August 20, 2018
BOARD OF COUNTY COMMISSIONERS
ORANGE COUNTY, FLORIDA
Addendum No. 1, IFB Y18-789-EB
BARBER PARK PLAYGROUND IMPROVEMENTS

Bid Opening Date: August 30, 2018

CONSTRUCTION PLANS FOR ORANGE COUNTY PARKS & RECREATION BARBER PARK PLAYGROUND IMPROVEMENTS DISTRICT NUMBER 3 ORANGE COUNTY, FLORIDA

PLAYGROUND COMPONENTS

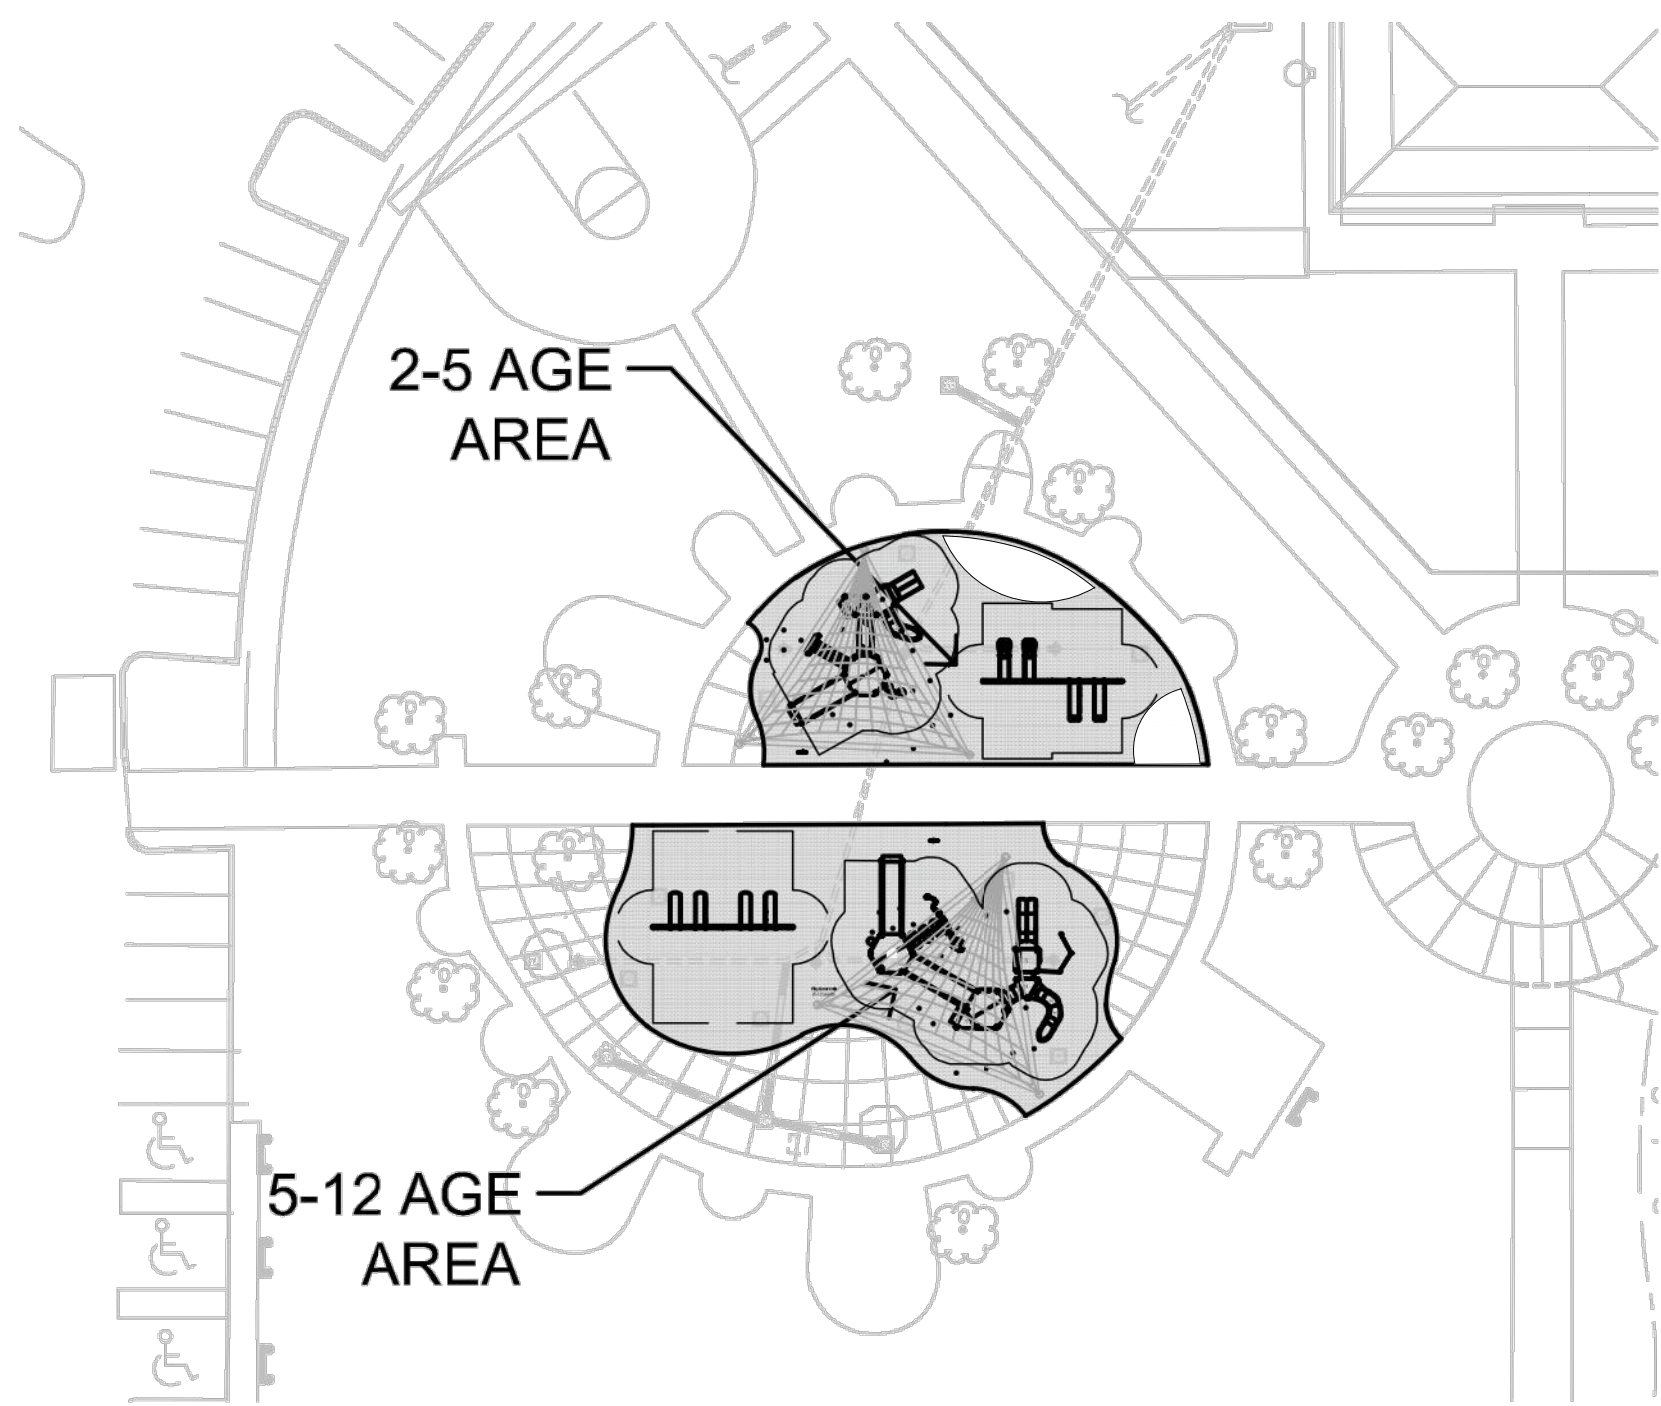
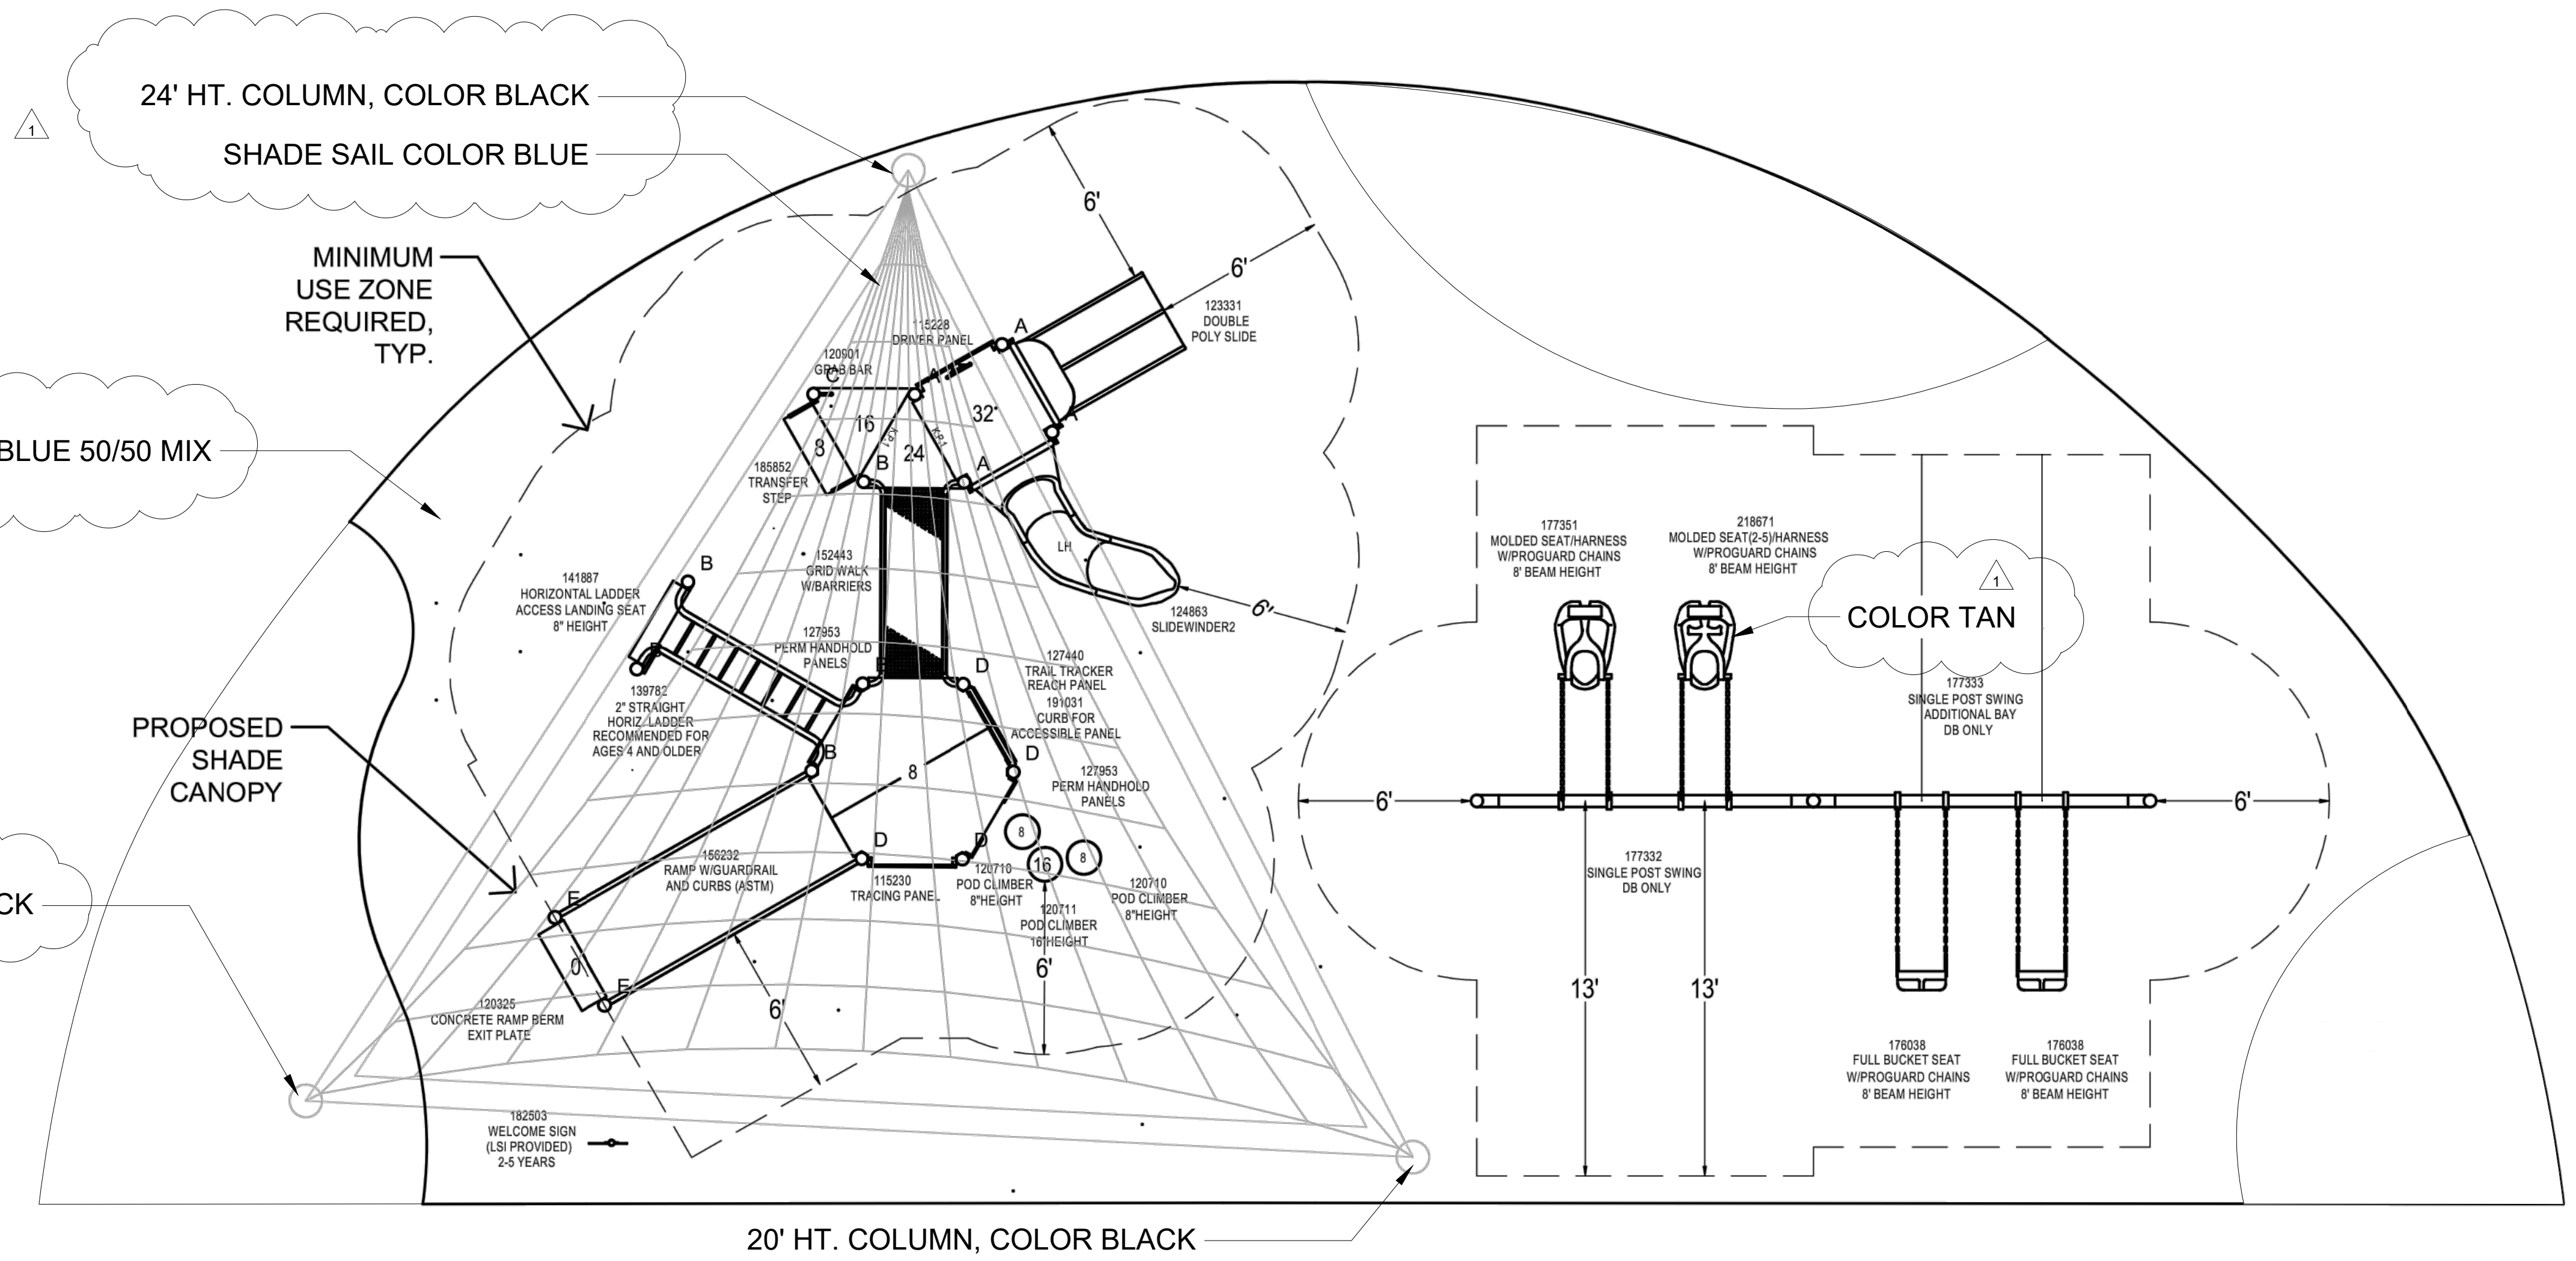
- Bottom of Curb elevation revised.
- Sheet C.8 Details - Construction
 - Detail #2: ‘EPDM Typical Safety Surface Wear Course Application’ revised.
- Sheet P.1 Playground Components

- Safety surface area revised.
 - Shade sail color added.
 - Column height and color added.
 - Swing seat color added
 - Basis of Design added
- Sheet P.2 Playground Layout & Components
